## GROUP 54

# CHASSIS ELECTRICAL

#### OUTLINE OF CHANGES

#### INSPECTION CHART FOR DIAGNOSIS CODES

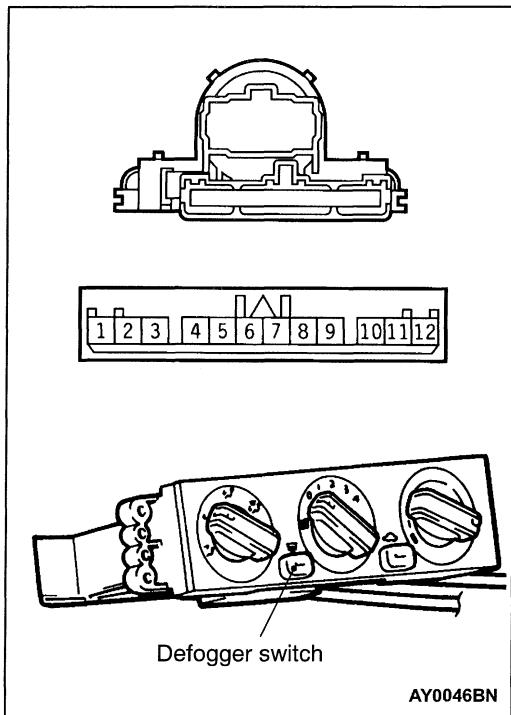
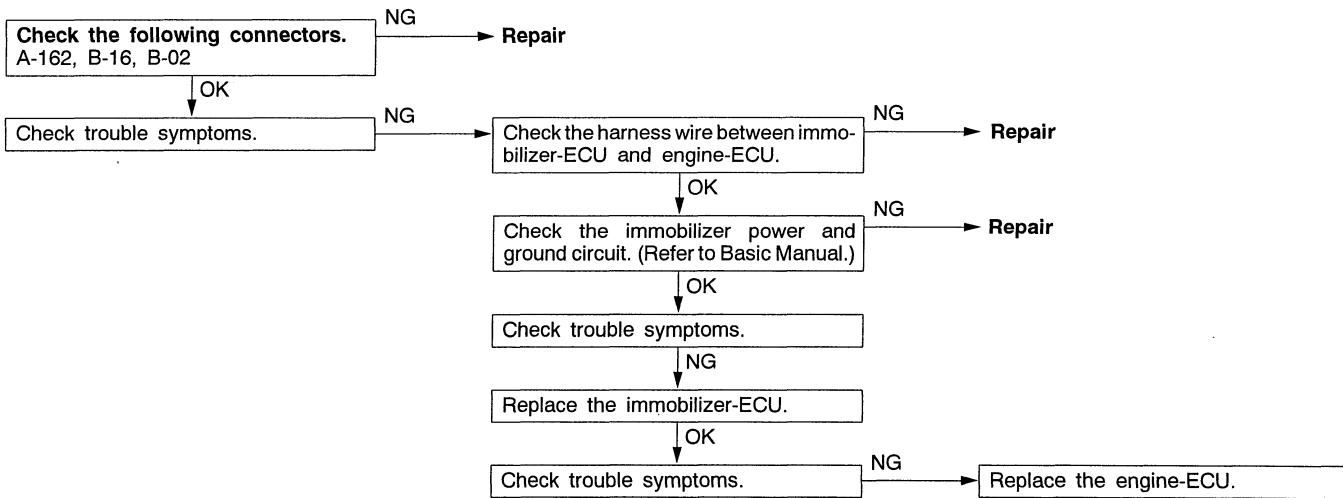
- Troubleshooting procedures have been changed as the immobilizer-ECU has been changed due to changes on the diesel engine <Diesel-powered vehicles>.
- The SRS warning lamp bulb inside the combination meter has been changed from 0.84 W to 1.4 W.
- The GDI ECO indicator lamp inside the combination meter can be dimmed by operating the rheostat.
- The defogger switch inspection procedure has been added as the timer function of the rear window defogger has been discontinued <Vehicles with manual air conditioner>.

Diagnosis code No.	Inspection items	Reference page
11	Transponder communication system	–
12	ID code are not the same or are not registered	–
21	Communication system between immobilizer-ECU and engine-ECU	54-2

Code No.21 Communication system between immobilizer-ECU and engine-ECU	Probable cause
After the ignition switch is turned to the ON position, the confirmation code is not received from the engine-ECU within the allowable time, or an abnormal code is received.	<ul style="list-style-type: none"> <li>• Malfunction of harness or connector</li> <li>• Malfunction of the engine-ECU</li> <li>• Malfunction of immobilizer-ECU</li> </ul>
